BALTIMORE COUNTY, MARYLAND
DEPARTMENT OF PUBLIC WORKS AND TRANSPORTATION
DIVISION OF CONSTRUCTION CONTRACTS ADMINISTRATION
111 WEST CHESAPEAKE AVENUE
TOWSON, MARYLAND 21204

Contract Number 24084 SX0
Richlyn Manor Force Main
Perry Hall – District 11c5
Workday Number PROJ-1000060

ADDENDUM NO. 1

DATE: 5/14/2026

PLAN: STA. 38+50 TO STA. 43+50
SCALE: 1"=20'-0"

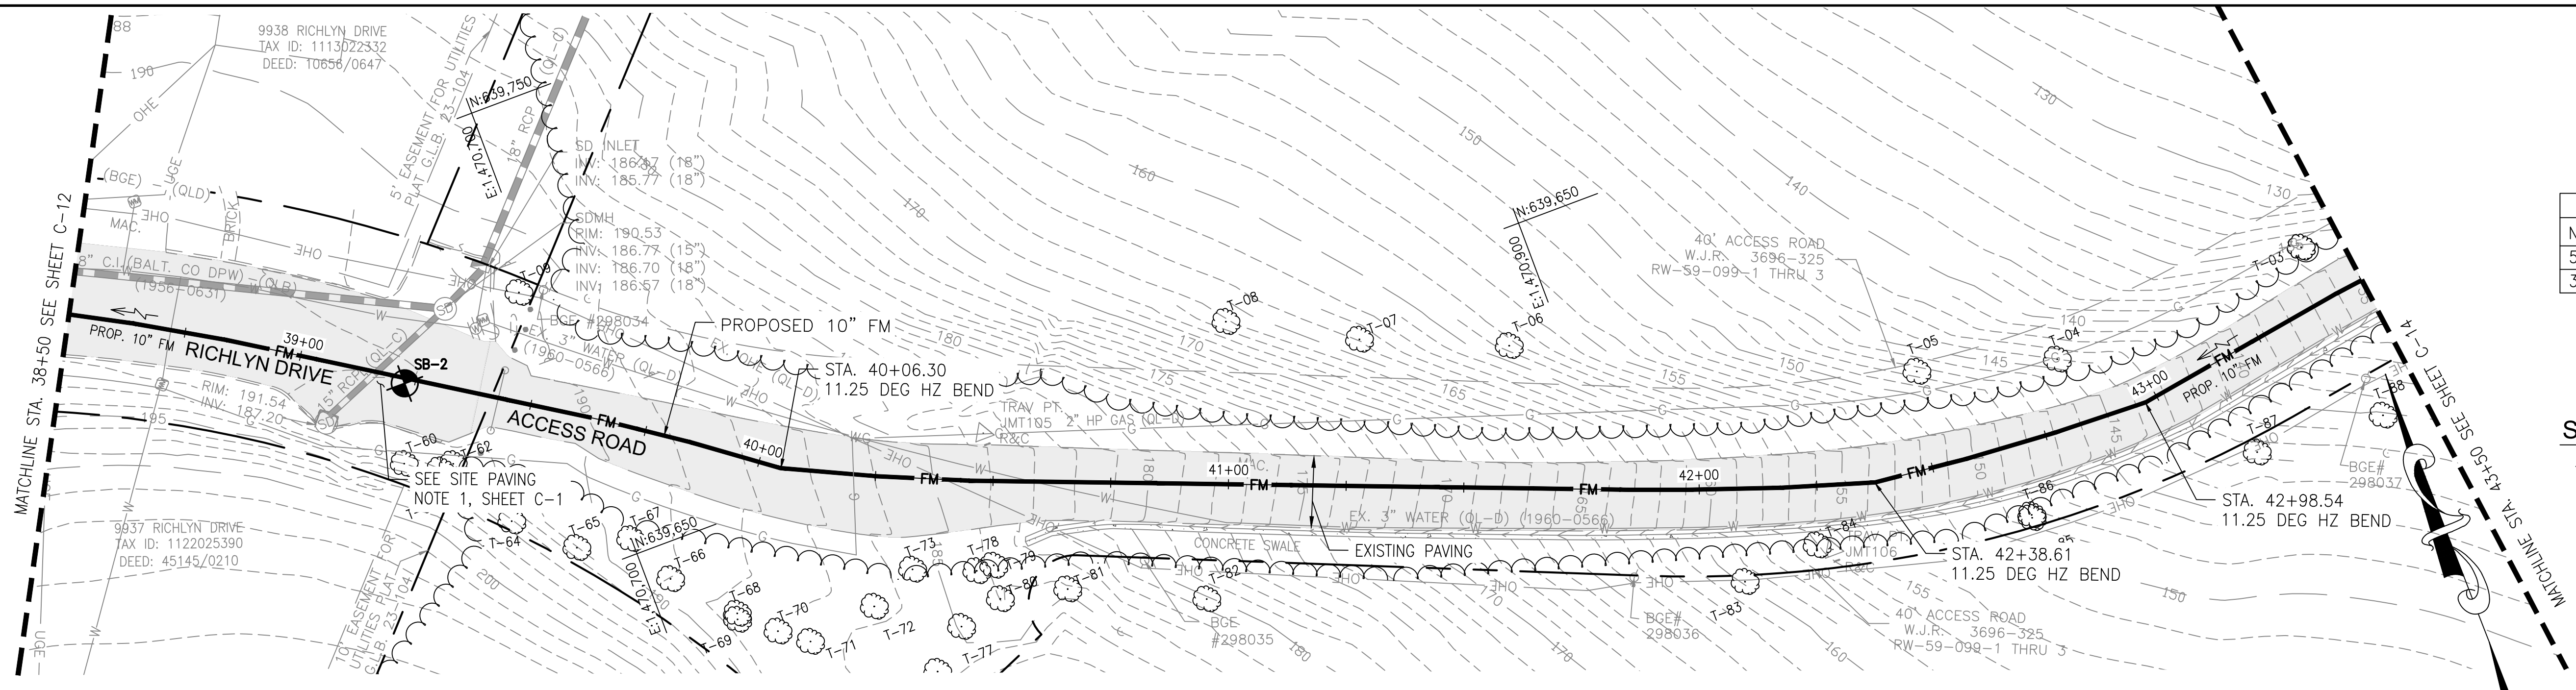
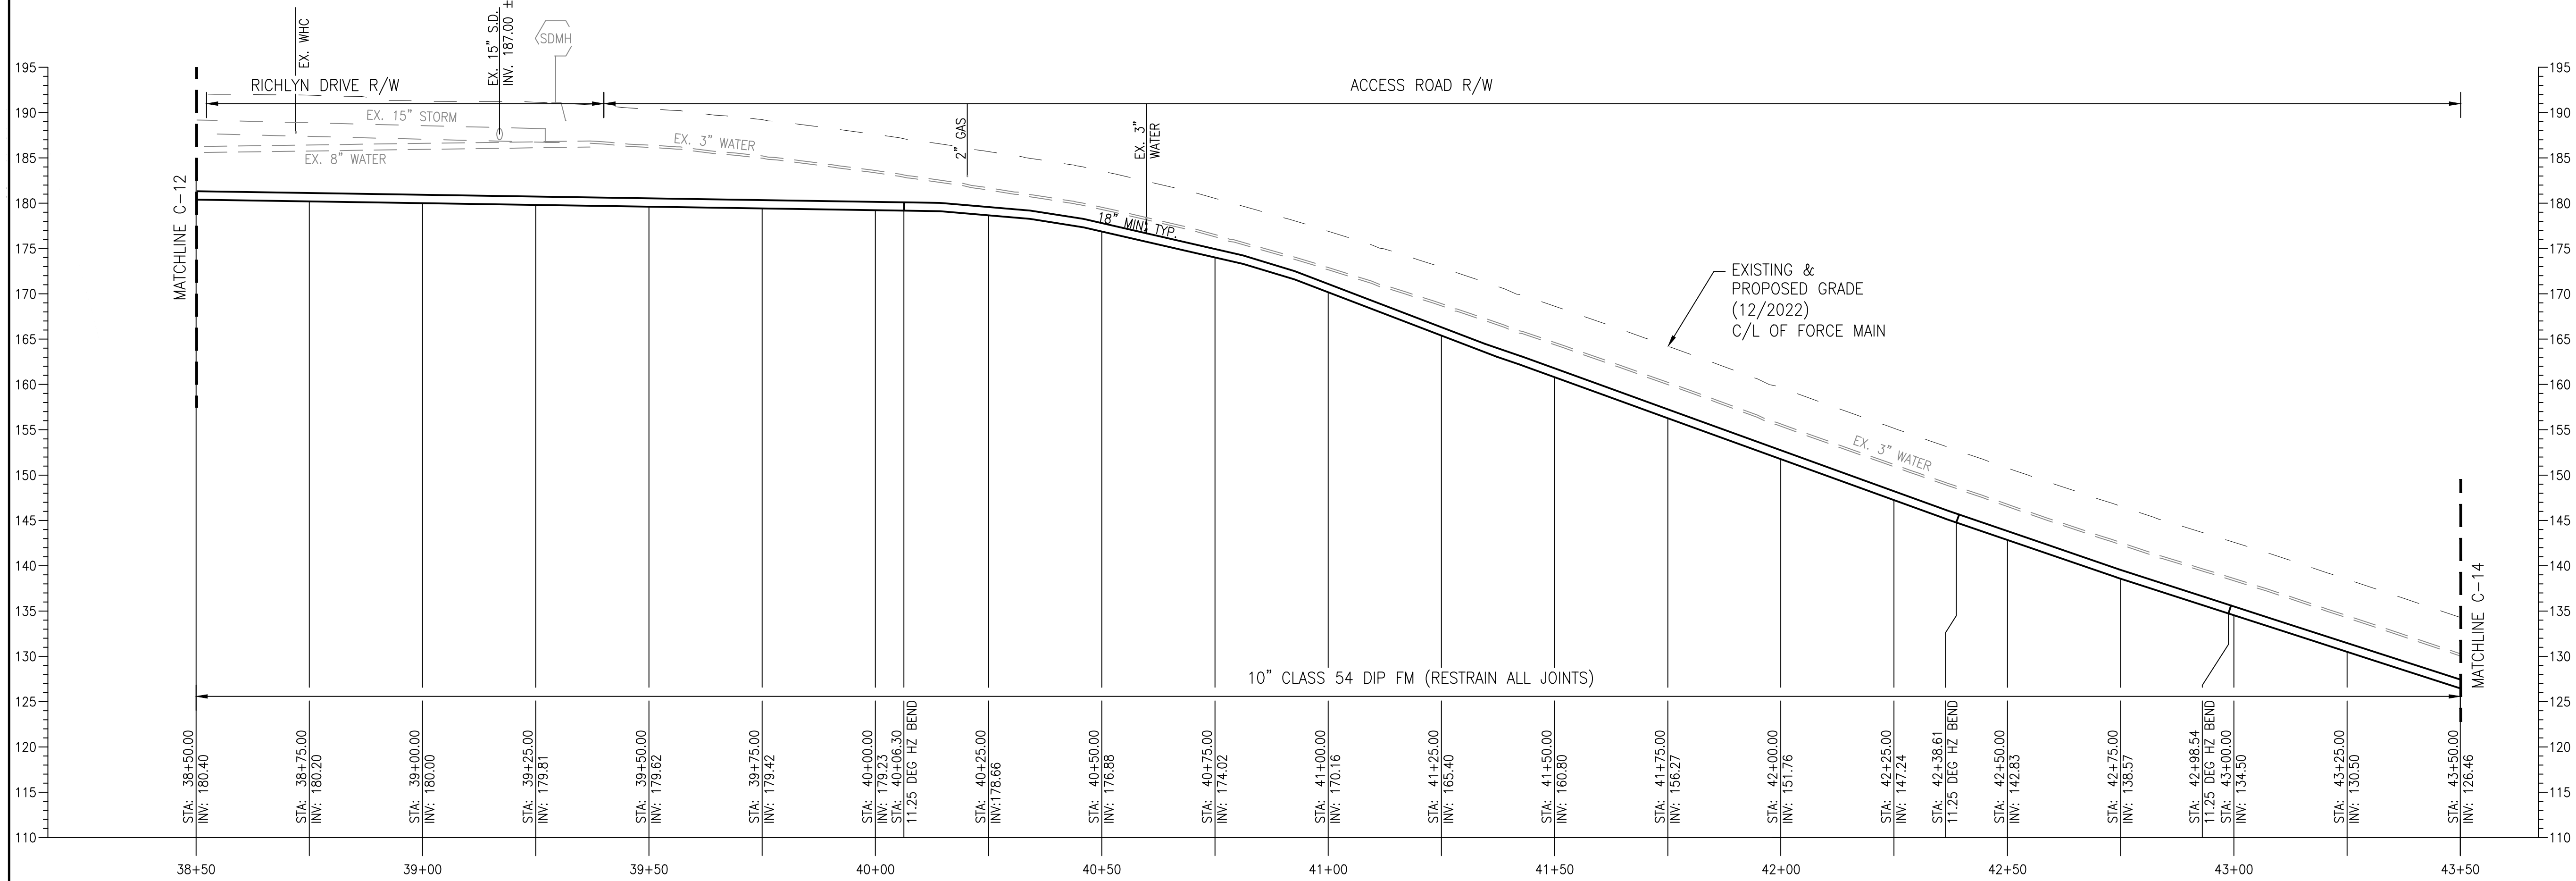
8. Drawing 2024-1150, C-13: Replace Sheet C-13 in its entirety with the attached revised Sheet C-13, which has been updated to include 2" BGE gas line near STA 40+25.00 and to revise BGE pole numbering.

PLAN: STA. 43+50 TO STA. 44+44
SCALE: 1"=20'-0"

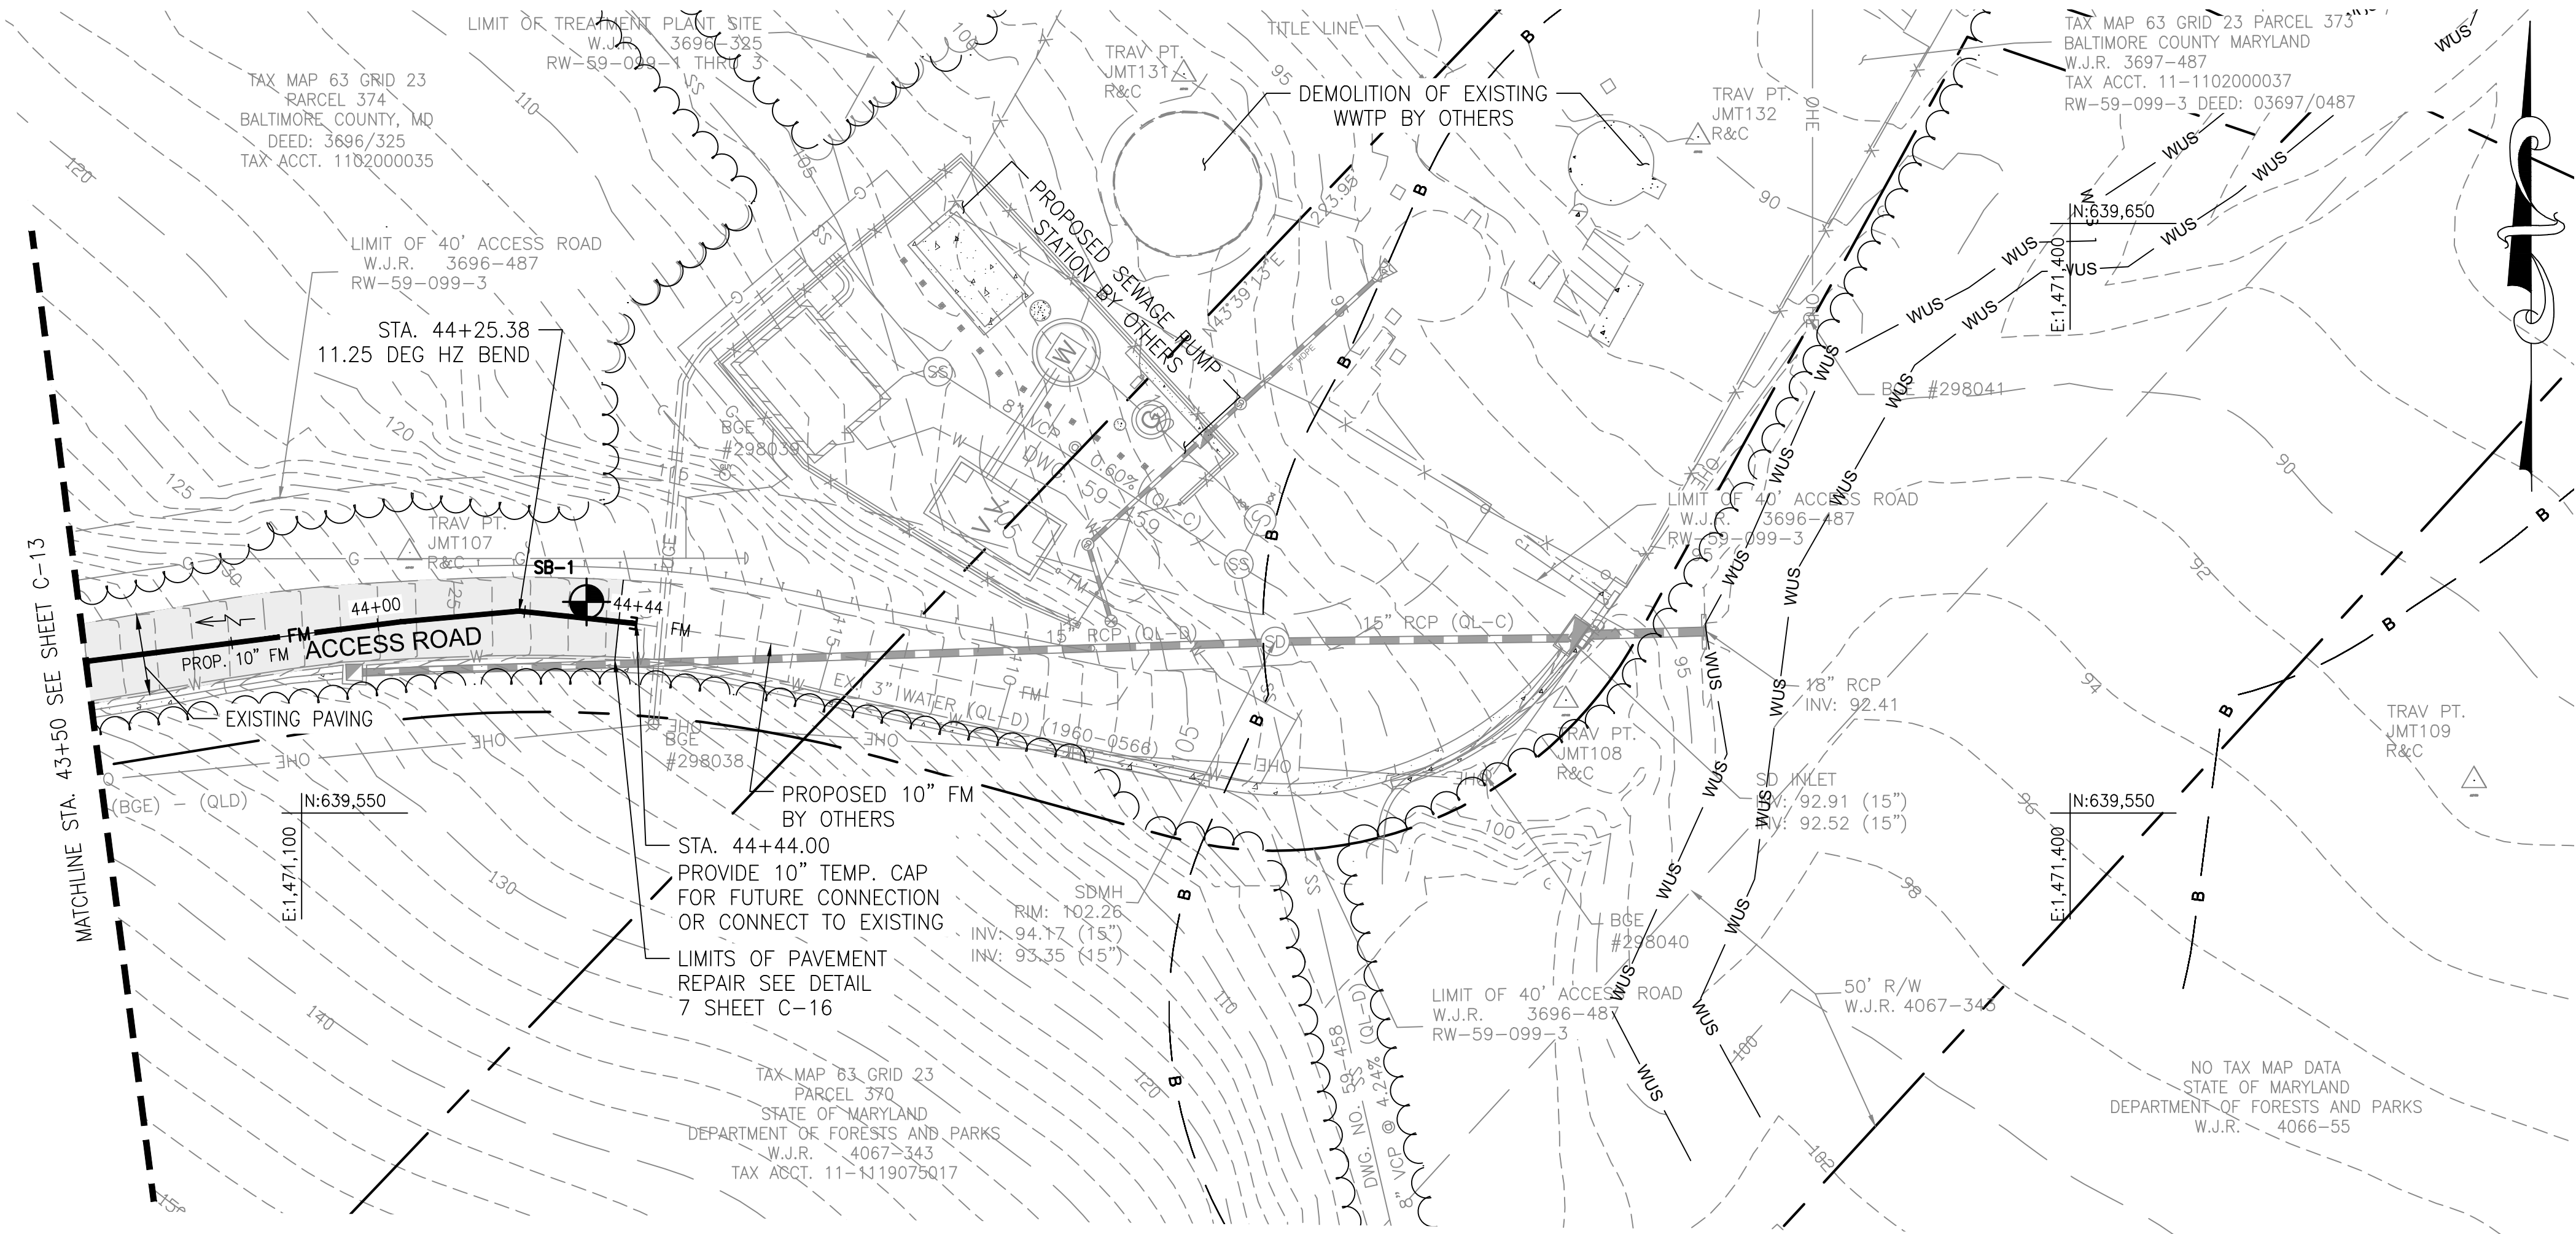
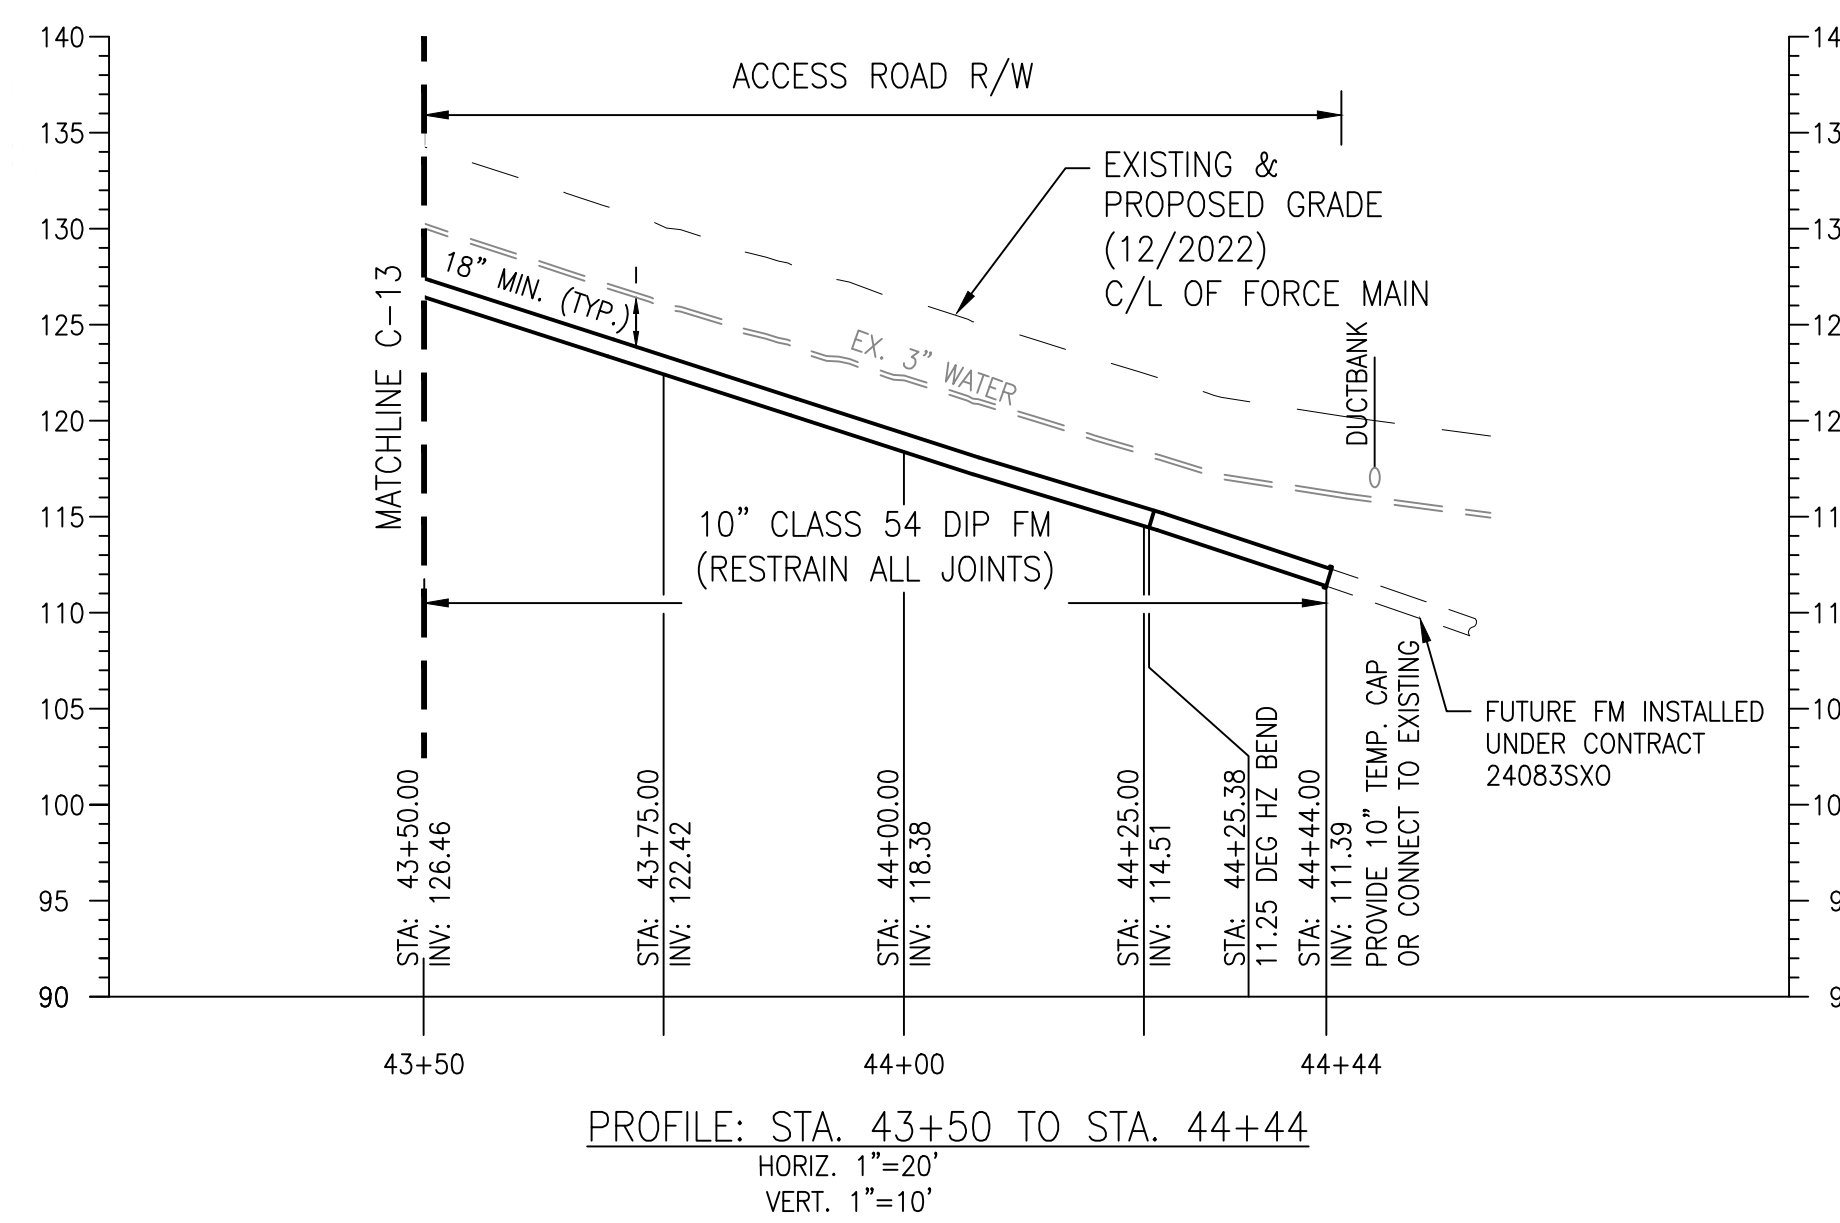
9. Drawing 2024-1151, C-14: Replace Sheet C-14 in its entirety with the attached revised Sheet C-14, which has been updated to include BGE underground electrical service ductbank in the vicinity of STA 44+44.00.
